The Rover Company Limited, Solihull,
Warwickshire, England

August, 1972

SUBJECT: MAIN HARNESS, REPOSITIONING

MODEL: Land-Rover Series III 2¼ litre Petrol

Fig. 1 Correct location of solenoid feed wire

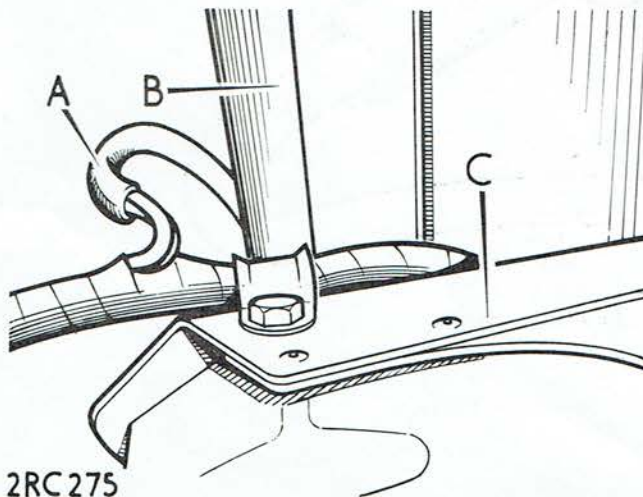
MODIFICATION: Introduction of modified main harness to prevent a foul condition between air cleaner, harness and wing valance.

It has been brought to our attention that in certain instances a 'foul' condition may be present between the air cleaner, main harness assembly and the right hand side wing valance.

Service personnel are requested to examine all earlier vehicles, during routine maintenance checks and, if required, peel back the non-adhesive harness binding tape, thus allowing the solenoid feed wire to be re-routed away from the obstruction.

Should the solenoid feed wire be badly chafed, it should be replaced with the modified main harness assembly.

Fig. 2 Identification of ignition lead

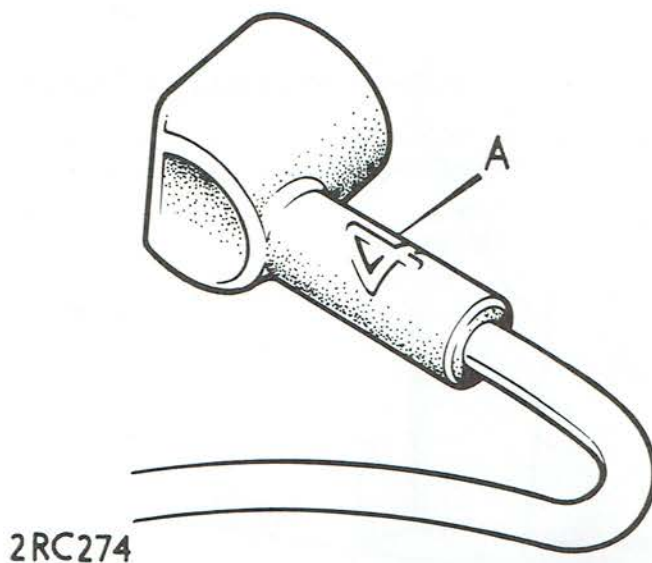
Several cases of engine misfire, and poor starting under wet or damp conditions have been reported and investigation has shown this to be caused by poor moulding of the right angled coil boot on the coil to distributor high tension ignition lead.

If this condition is detected or brought to your attention by an owner, on vehicles sold during the last 12 months, then the coil to ignition lead must be changed for the modified type, which has a moulding number stamped on the right angled coil boot. The earlier type has no moulding number.
